SUBDIVISION REPORT - CONCEPT

▶ FILE #:	7-SB-21-C	AGENDA ITEM #:	19
POSTPONEMENT(S):	7/8/2021 - 8/12/2021	AGENDA DATE:	9/9/2021
▶ SUBDIVISION:	CAPITAL DRIVE		
▶ APPLICANT/DEVELOPER:	PATRICK SCHAAD TRUSTEE		
OWNER(S):	Schaad Residential Real Estate		
TAX IDENTIFICATION:	131 122 & 122.24 (PART OF)	<u>View map on KGIS</u>	
JURISDICTION:	County Commission District 3		
STREET ADDRESS:	9933 & 0 Kingston Pk.		
▶ LOCATION:	North side of Kingston Pike at Capital Drive		
SECTOR PLAN:	Southwest County		
GROWTH POLICY PLAN:	Urban Growth Area		
WATERSHED:	Sinking Creek		
▶ APPROXIMATE ACREAGE:	2.153 acres		
▶ ZONING:	CB (Business and Manufacturing)		
▶ EXISTING LAND USE:	Retail store, vacant land		
▶ PROPOSED USE:	Commercial subdivision		
SURROUNDING LAND USE AND ZONING:	North: Vacant land -- CB (Business and Manufacturing) South: Kingston Pike -- OP (Office Park) and PC (Planned Commercial) East: Church -- C-H-1 (Highway Commercial) West: Retail and vacant land -- I-G (General Industrial) and C-H-2 (Highway Commercial)

7-SB-21-C CONCEPT PLAN

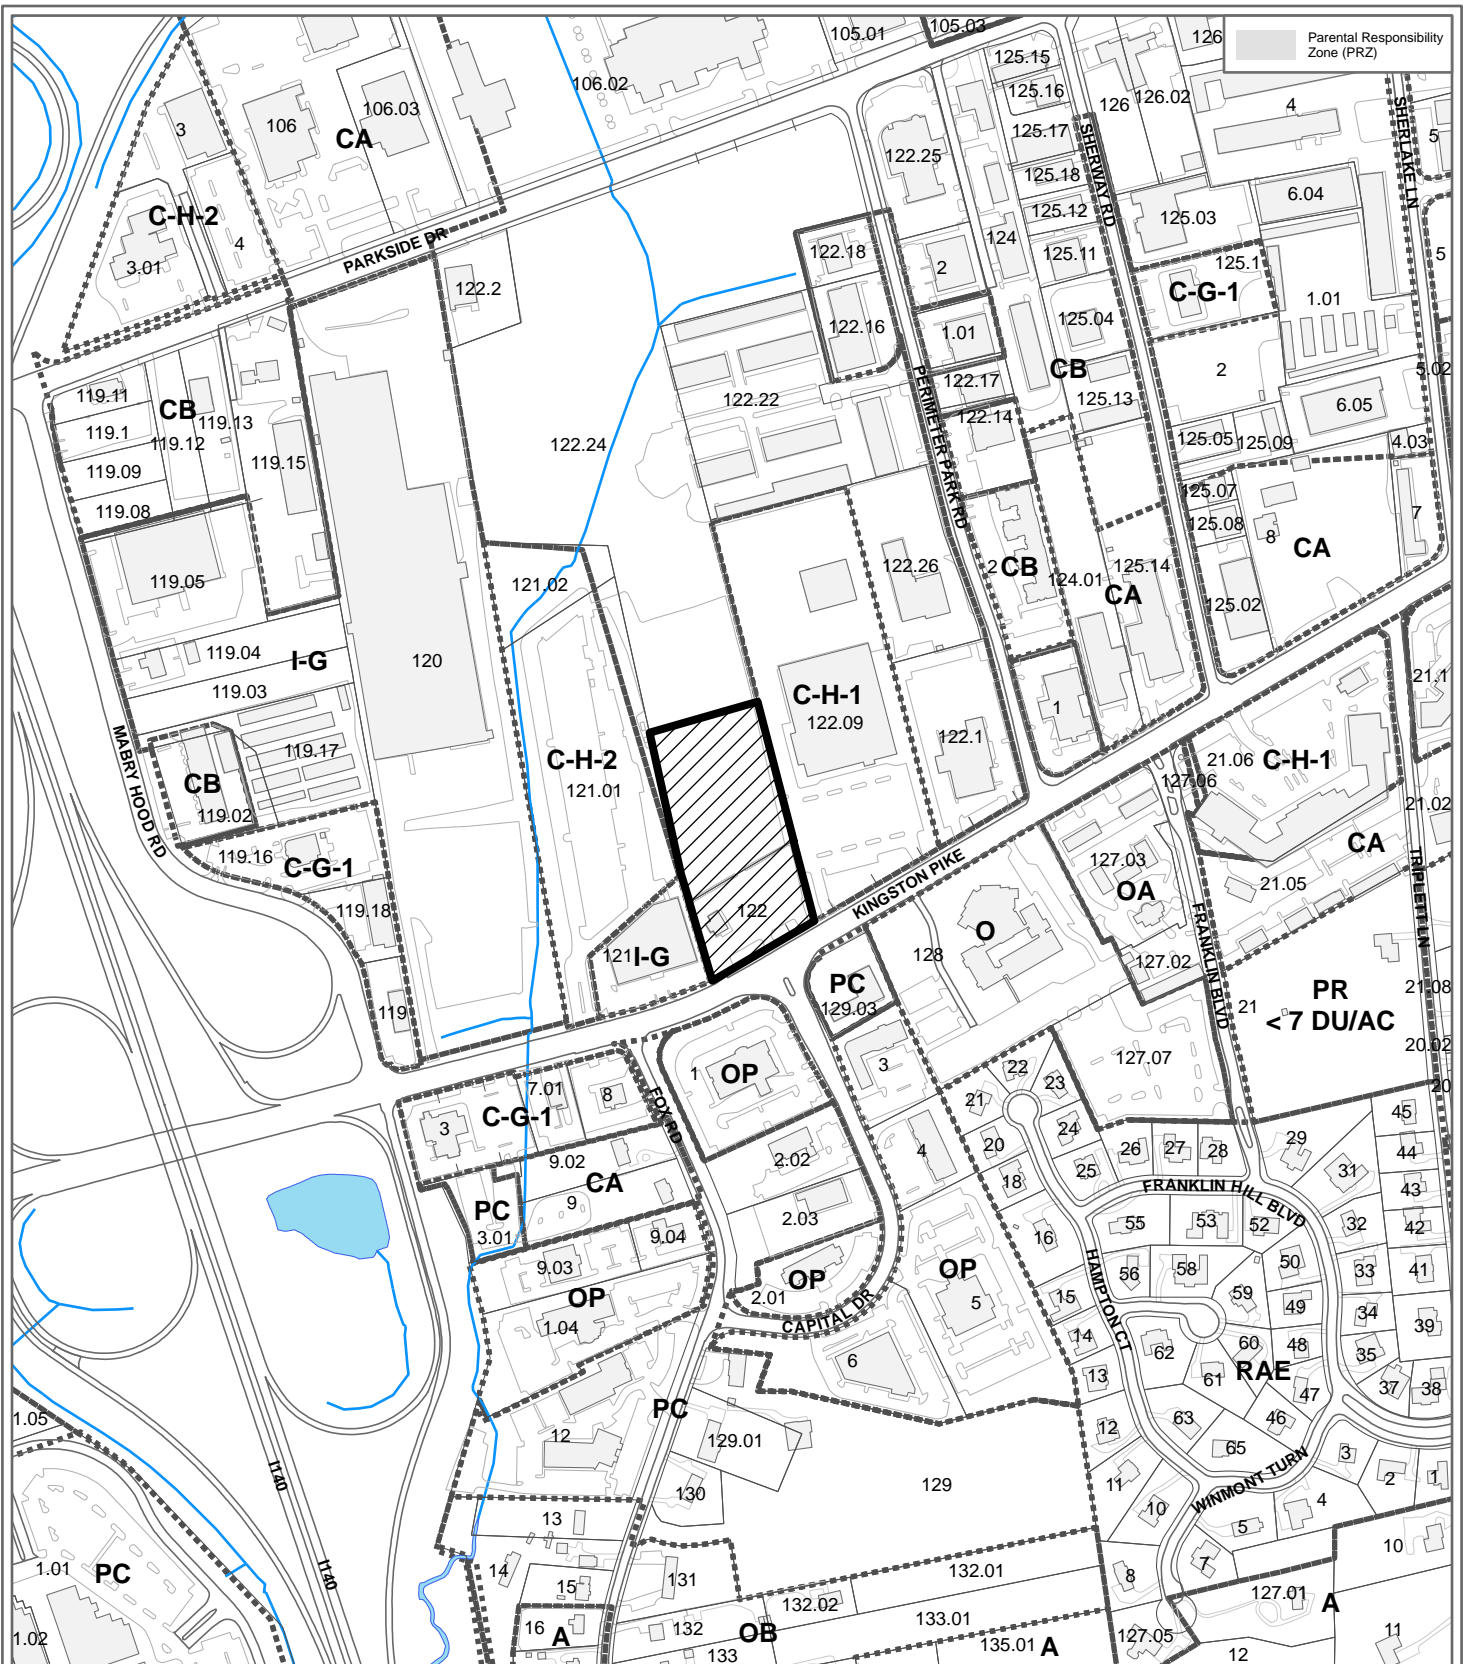
This proposal is for a 4-lot commercial subdivision and a new 3-lane public road, located on the north side of Kingston Pike at the Capital Drive intersection. The new road (Commercial Drive) is currently proposed to be approximately 400-ft long, however, it is anticipated that it will be extended further to the north in the future and potentially connect to Parkside Drive. The subject property and the new road are located in Knox County (outside the City limits), the right-of-ways for Kingston Pike and Capital Drive are within the City of Knoxville, and Kingston Pike is a U.S. route maintained by the Tennessee Department of Transportation (TDOT). The new road must meet the standards for Knox County but the Kingston Pike and Capital Drive intersection improvements must meet the requirements of the City of Knoxville and TDOT.

The traffic signal at this Kingston Pike intersection must be modified to accommodate the new road and the Capital Drive intersection on the south side of this intersection needs to be reconfigured to function properly with the addition of the new road. When Capital Drive was constructed, it was in Knox County and was subsequently annexed into the City of Knoxville. There is a landscape island with a directory sign for the office development in the middle of Capital Drive at the Kingston Pike intersection. It is unknown when this sign was installed but it and the landscape island are in the public right-of-way and must be removed as part of the intersection improvements to create a dedicated left-turn lane.

The City of Knoxville requires sidewalks to be installed along road frontages when a property is developed or redeveloped, so a sidewalk along the Kingston Pike frontage is required. The developer can make a formal request to the City of Knoxville Director of Engineering for a waiver to this requirement, however, this has not been requested as of the publication of this staff report and there is no guarantee this waiver will be approved. The existing detention ponds on lots 1 and 4 will be modified with the installation of the new road, however, the concept plan does not show a preliminary design for these modifications. The primary concern is how the pond on Lot 4 will impact the parking lot design for the existing business.

► **Postpone the Concept Plan application until the October 14, 2021, Planning Commission meeting as requested by the applicant.**

Figure 9

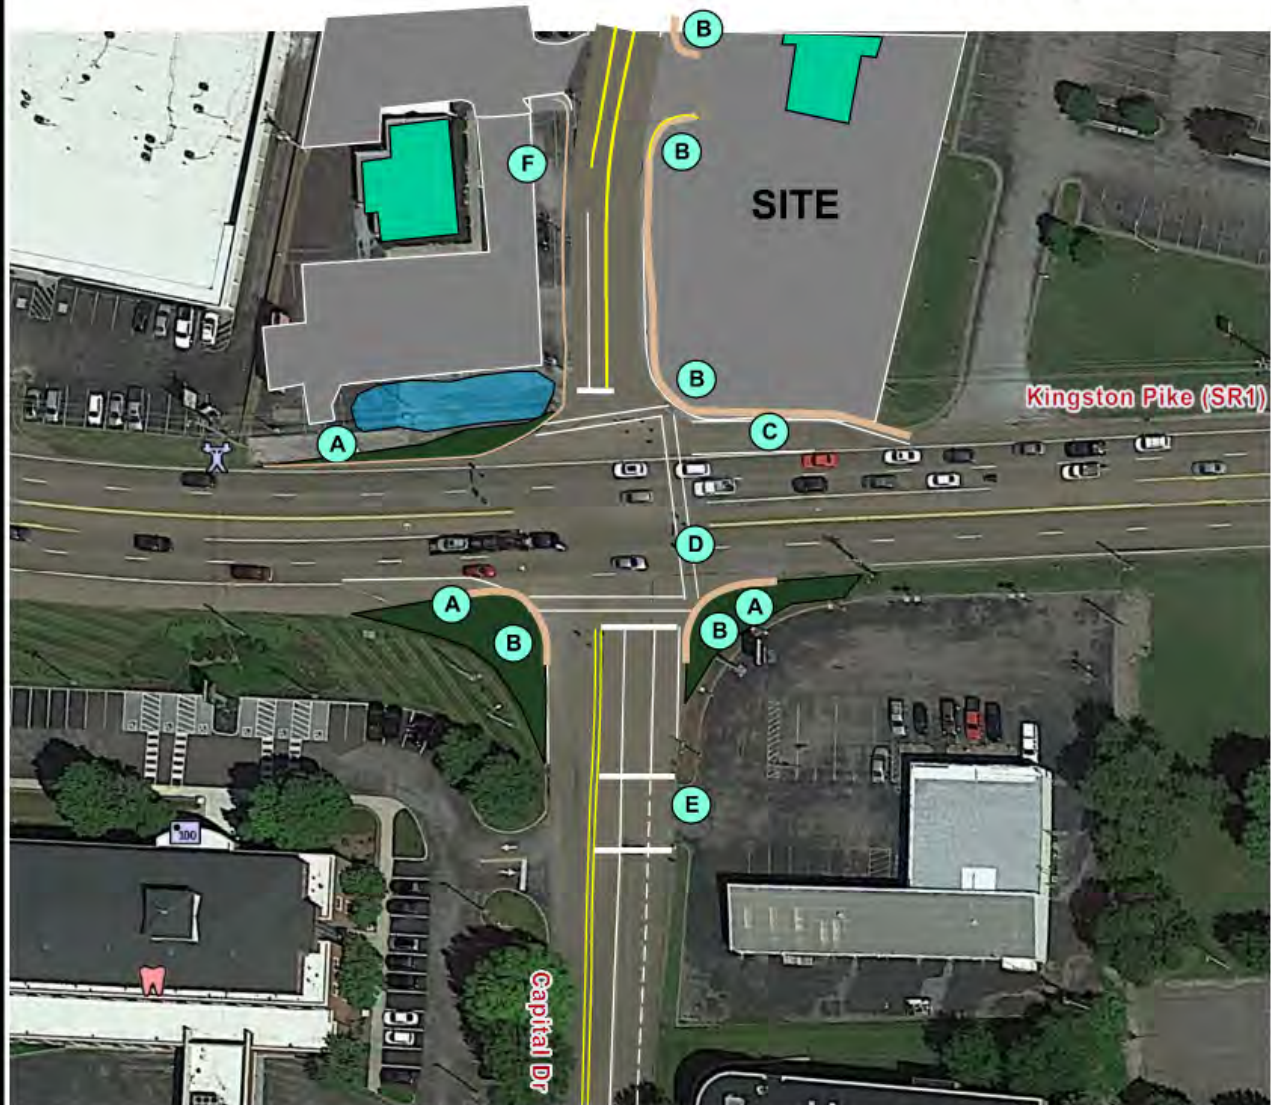
- Provide 100-foot storage for a left-turn lane on the new connector stub road at the southbound approach to Kingston Pike as shown in **Figure 9**.
 - Ensure there are no driveway openings to the GemStore and proposed retail developments within this storage length.

- Reconfigure the northbound approach on Capital Drive to provide a 300-foot storage left-turn lane, a separate through lane, and a separate right-turn lane as shown in **Figure 9**.

- Provide a 50-foot storage westbound right-turn lane on Kingston Pike via appropriate striping as shown in **Figure 9**.
- City of Knoxville staff have indicated that sidewalks will likely be required both internally along the new connector stub of Capital Drive and along the Kingston Pike road frontage. This will require the construction of sidewalk and ADA-compliant curb ramps along the proposed Kingston Pike westbound right-turn lane to Capital Drive, around the radii of the new connector stub road, and any connecting corners of the study intersection.

- Provide crosswalk striping from the northwest to northeast to southeast corners of the study intersection as shown in **Figure 9**.
- Post STOP signs (R1-1) for exiting traffic from the GemStore, proposed coffee/donut shop, and proposed retail strip development driveways located along the new connector road north of Kingston Pike.
